Model: Mojito		Date: 10-Nov-00	No.: RA293015
Subject: Printer Controller (B337) System Firmware Histories		Prepared by: A. Sasaki	
From: Technical Service Dept., GTS Division			
Classification:	<input type="checkbox"/> Troubleshooting <input type="checkbox"/> Part information <input type="checkbox"/> Action required <input type="checkbox"/> Mechanical <input type="checkbox"/> Electrical <input type="checkbox"/> Service manual revision <input type="checkbox"/> Paper path <input type="checkbox"/> Transmit/receive <input type="checkbox"/> Retrofit information <input checked="" type="checkbox"/> Other (Information)

This is to inform about the modification histories of the system firmware of Printer Controller Type 700 (B337).

Model: Bellini		Date: 23-Aug-00	No.: RA294030
Subject: Interface Board Installation		Prepared by: A. Sasaki	
From: Technical Services Dept., GTS Division			
Classification:	<input checked="" type="checkbox"/> Troubleshooting <input type="checkbox"/> Part information <input type="checkbox"/> Action required <input type="checkbox"/> Mechanical <input type="checkbox"/> Electrical <input type="checkbox"/> Service manual revision <input type="checkbox"/> Paper path <

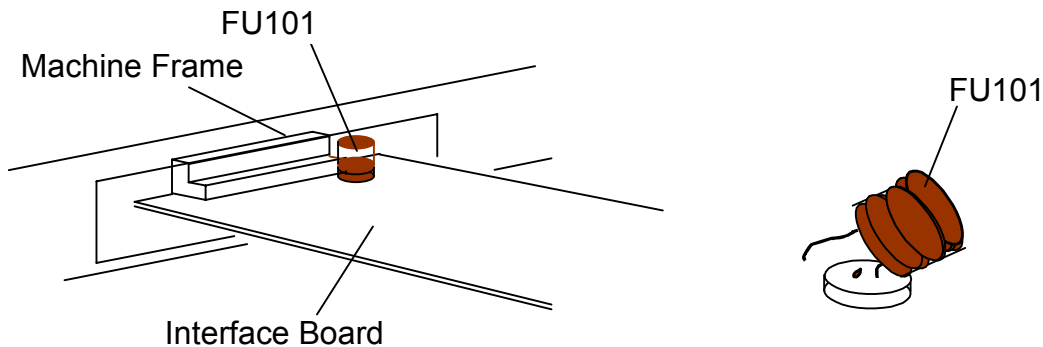
After inserting the interface board during installing any of the following optional equipment, the copier does not recognize them.

- Printer Controller
The printer feature menu in the user tools and SP mode does not appear on the operation screen.
- CD-RW
The CD-RW cannot be accessed in the Document Editor.
- Tandem Copy Kit
The "Copy Connect" key does not appear on the operation screen.

CAUSE

The fuse FU101 on the interface board is damaged.

When the interface board is inserted, the top part of the fuse brushes against the machine frame and a leg of the fuse comes loose.

Please make sure that the fuse on the interface board does not touch the machine frame when you insert the interface board.
